APPEAL SUMMARY

| Appeal ID: 27498 | Project Address: 1417 NW 20th Ave | |
| Guilding/Business Name: Block 290 Apartments Fire Sprinklers: Yes - Throughout | | |

SUBJECT: Block 290 East - Geotechnical Demolition Recommendations

Attachment – Figure 2 (from CMMP)

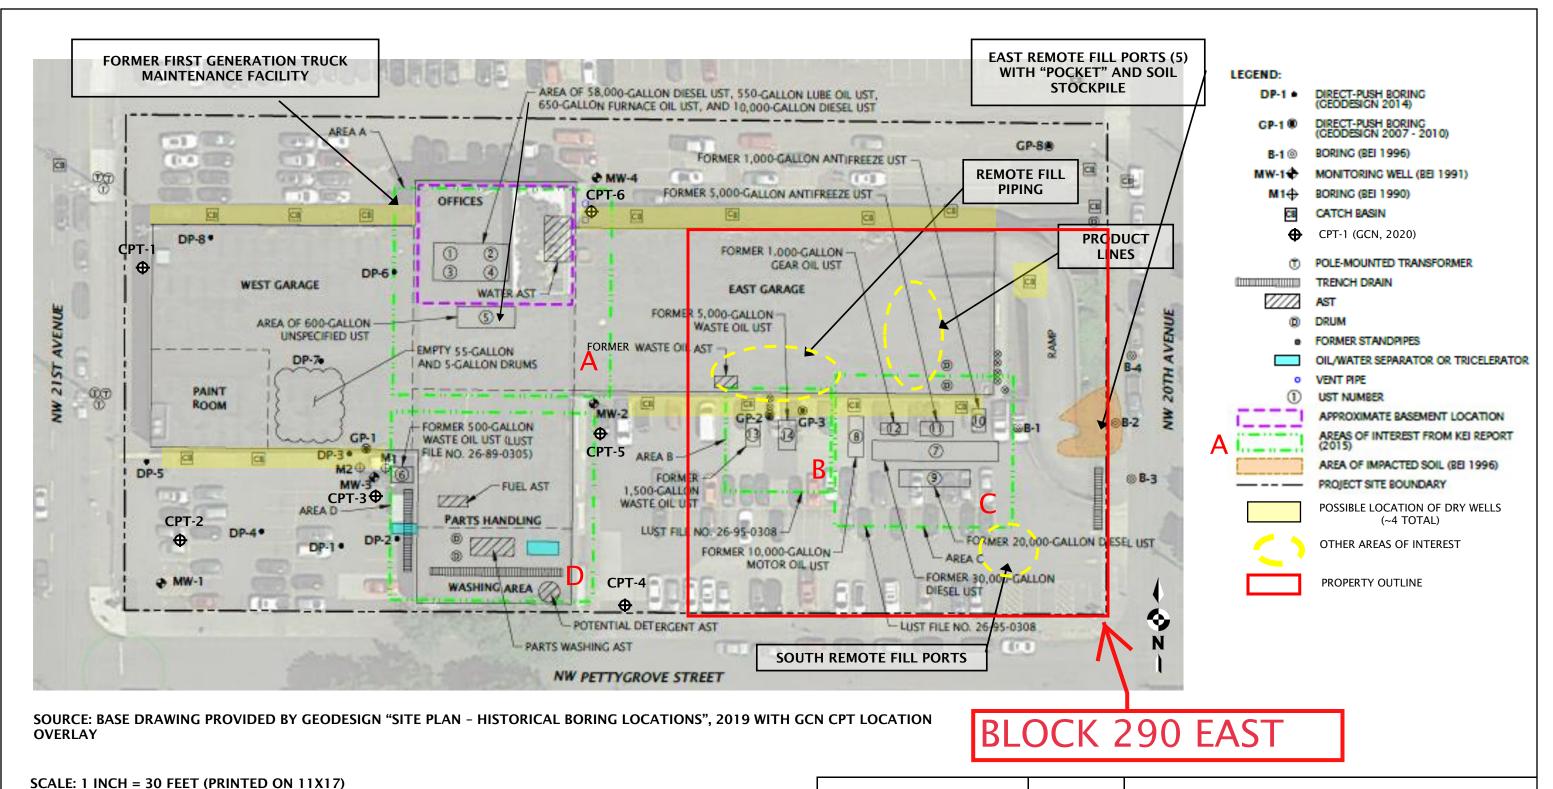
Precise locations of suspected contaminated soil, contaminated above Oregon DEQ screening thresholds, is not known but is anticipated based on the locations of historic truck maintenance and fueling operations (refer to attached Figure 2 from the CMMP dated 6/7/2021 for the East Block). Most of the areas are underground storage tanks (USTs) sites and, both inside/outside the building, and underground piping connected to the USTs. There also may be suspect stormwater dry wells, underground UST piping, and USTs not previously discovered but remaining on the property, and, if encountered, should be removed to confirm "clean" conditions per DEQ guidance.

- 5. Native soil (or crushed rock over native soil) is exposed in a small area between the east side of the building and the sidewalk. Within this area, the historic record suggests that there is a small stockpile of petroleum contaminated soil over a small/shallow pocket of petroleum contaminated soil (refer to attached Figure 2 from the CMMP dated 6/7/2021 for the East Block). Following demolition, the owner/contactor managing demolition of the entire building need to conduct a visual review this area to determine the best practice for keeping stormwater off this area. At this time, we propose covering this area with water, sunlight, and vandalism resistant sheeting and collecting/diverting stormwater from this sheeting to a suitable outlet.
